# Access Compliance Report

## Public Rights-of-Way

Intersection ID: 6837	Main Street: ROUNDEAF_DR	Cross Street: SAWYER_DR	Location: NE
ADA ID: 51EE43BB3C08	Ramp Type: Perp	Initial Pass/Fail: Fail	Overall Compliance: No
		Severity Score: 40

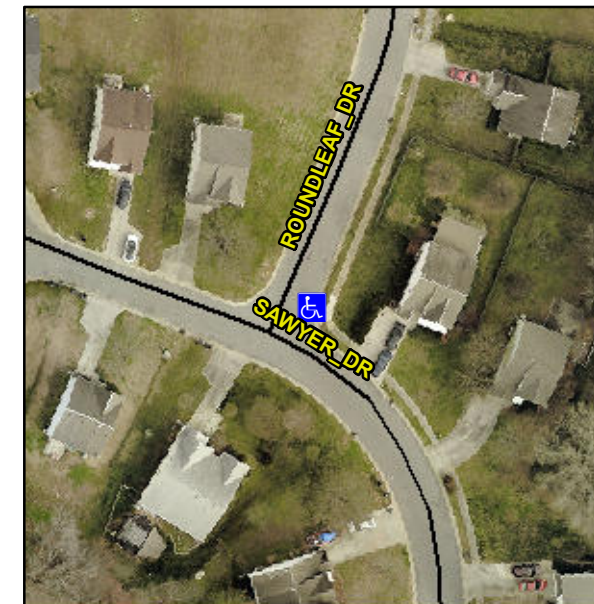
**Not Found, R304.2.2, R304.5.3, R302.7**

Compliance	Description	Data	Compliance	Description	Data
N/A	Ramp Length (in)	46.0	No	Ramp Slope (%)	11.5
Yes	Ramp Width (in)	67.0	No	Ramp XSlope (%)	5.1
N/A	Flare Type LT	N/A	N/A	Flare Type RT	N/A
N/A	Flare Slope LT (%)	N/A	N/A	Flare Slope RT (%)	N/A
N/A	Flare Traversable LT?	N/A	N/A	Flare Traversable RT?	N/A
N/A	Landing Length (in)	N/A	N/A	DWS Provided?	N/A
N/A	Landing Width (in)	N/A	N/A	DWS Contrast?	N/A
N/A	Landing Slope (%)	N/A	N/A	DWS Length (in)	N/A
N/A	Landing X Slope (%)	N/A	N/A	DWS Full Width?	N/A
N/A	Landing Curb? (Y/N)	N/A	N/A	DWS Offset (in)	N/A
N/A	Shared Landing?	N/A			
N/A	Gutter Ponding?	N/A	N/A	Gutter Slope (%)	N/A
N/A	Gutter Lip Ht (in)	N/A	N/A	Gutter X Slope (%)	N/A
N/A	Painted X Walk1?	No	N/A	Painted X Walk2?	N/A
	X Walk 1 Direction	To NW		X Walk 2 Direction	N/A
N/A	X Walk 1 Width (in)	N/A	N/A	X Walk 2 Width (in)	N/A
	X Walk 1 Slope (%)	2.3		X Walk 2 Slope (%)	N/A
	X Walk 1 X Slope (%)	5.3		X Walk 2 X Slope (%)	N/A

**Remove & Replace Entire Ramp.**
